**SOLICITATION AMENDMENT
MODIFICATION DE L'INVITATION**

Title - Sujet Purchase of Shelving & Installation	
Solicitation No. - N° de l'invitation 5X001-170733/A	Amendment No. - N° modif. 003
Client Reference No. - N° de référence du client 5X001-170733	Date 2017-12-04
GETS Reference No. - N° de référence de SEAG PW-\$\$HN-465-73690	
File No. - N° de dossier hn465.5X001-170733	CCC No./N° CCC - FMS No./N° VME
Solicitation Closes - L'invitation prend fin at - à 02:00 PM on - le 2017-12-18	Time Zone Fuseau horaire Eastern Standard Time EST
F.O.B. - F.A.B. Plant-Usine: <input type="checkbox"/> Destination: <input checked="" type="checkbox"/> Other-Autre: <input type="checkbox"/>	
Address Enquiries to: - Adresser toutes questions à: Nadeau, Alexandra	Buyer Id - Id de l'acheteur hn465
Telephone No. - N° de téléphone (819) 420-2859 ()	FAX No. - N° de FAX (819) 953-4944
Destination - of Goods, Services, and Construction: Destination - des biens, services et construction:

This amendment 003 is being raised to address questions submitted by potential bidders and revise Annex A - Statement Of Work;

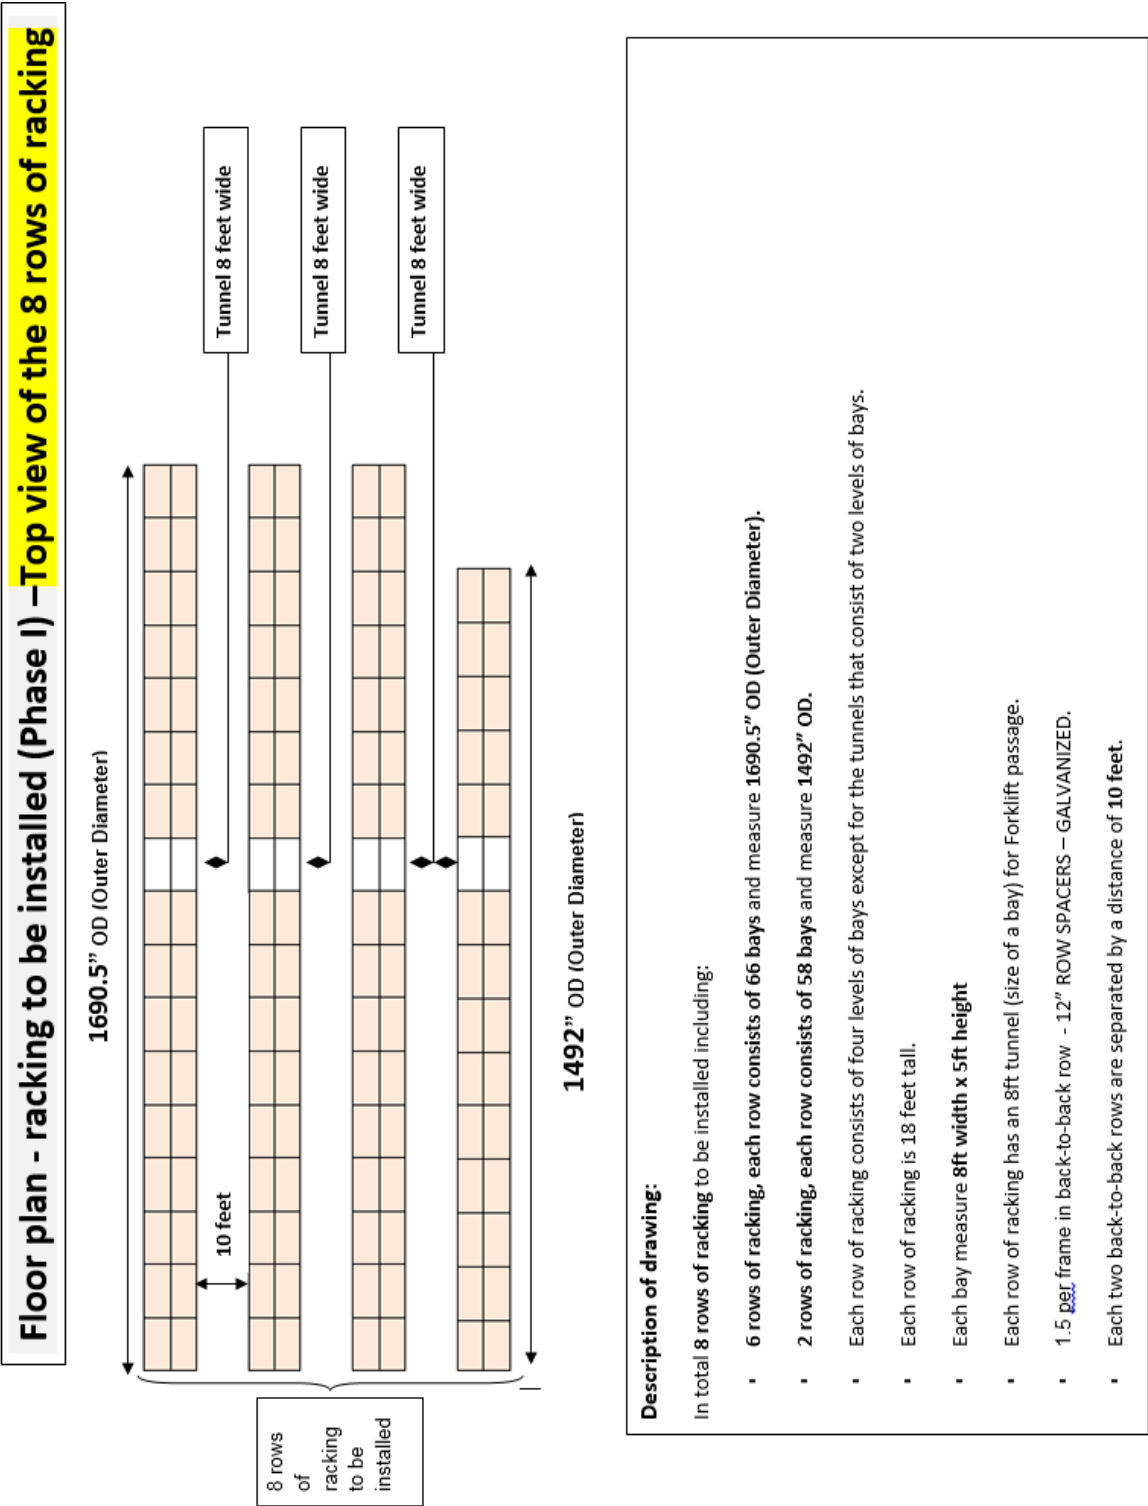
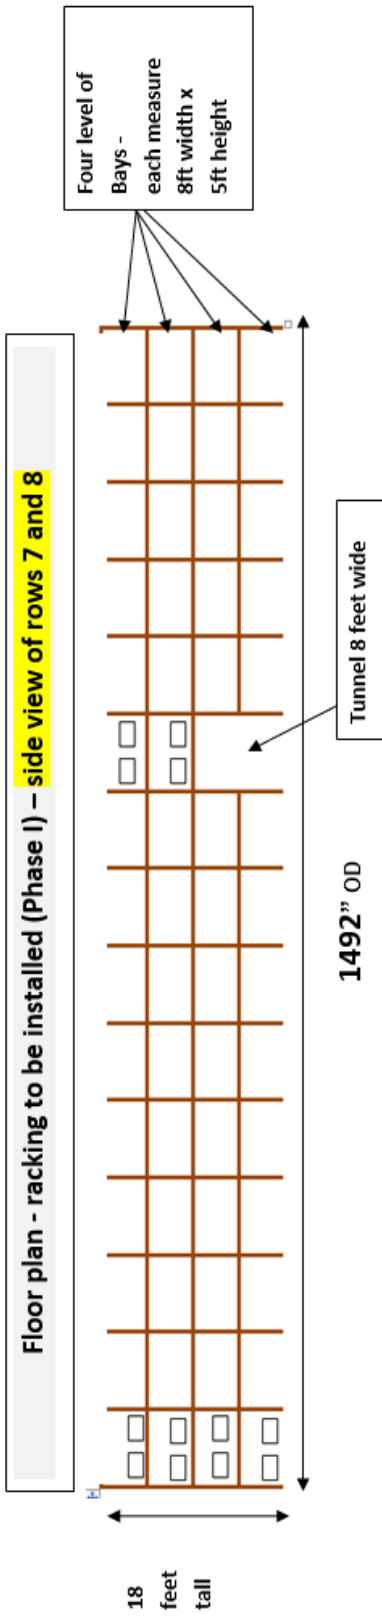
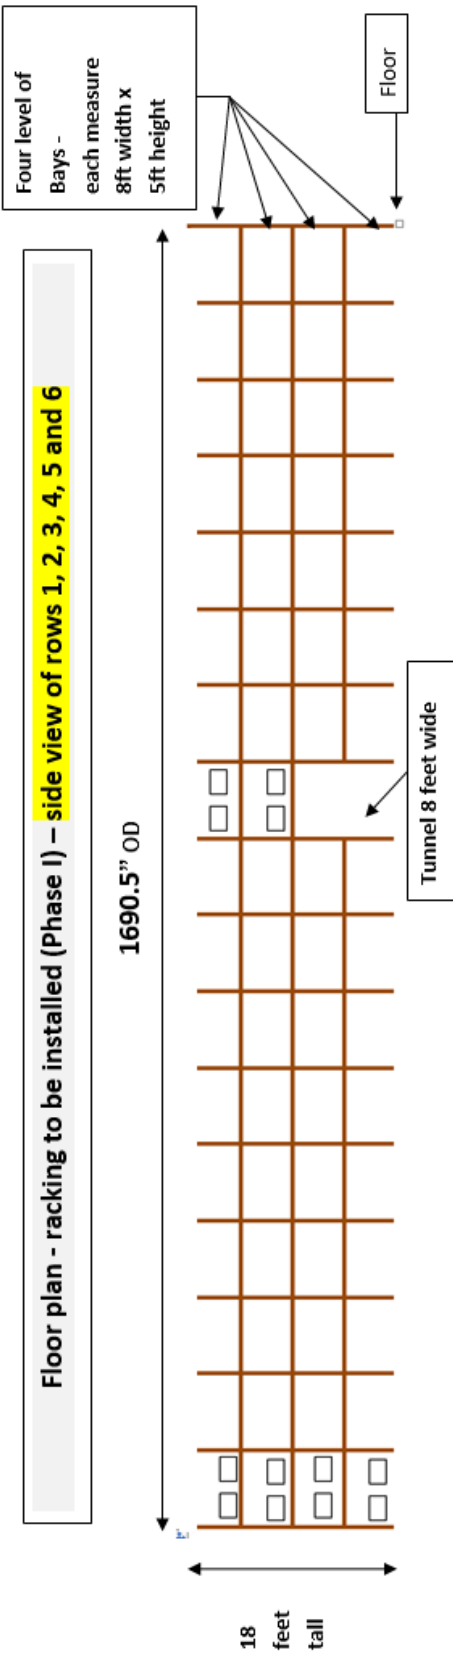
Q20) We posed the Q2 and Q3 in addendum 002 which clearly indicated that new drawings and descriptions had been provided. The new information provided leads to greater confusion. The drawing for Phase 1 shows 3 rows of 34 bays (17 bays x2) and 1 row of 30 bays(15 bays x2). The description calls for 3 rows of 66 bays and 1 row of 58 bays. Which governs: the drawing or the description? The same stands for Phase 2. Please clarify.

A20) The drawings provide top view as well as side of the racking. Please refer to both. We amended our drawing and description to eliminate confusion. Each row of racking consists of four levels of bays except for the tunnels that consist of two levels of bays. Looking at 1 row, we require 17 columns x 4 bays high – 2 bays for the tunnel = 66 bays.
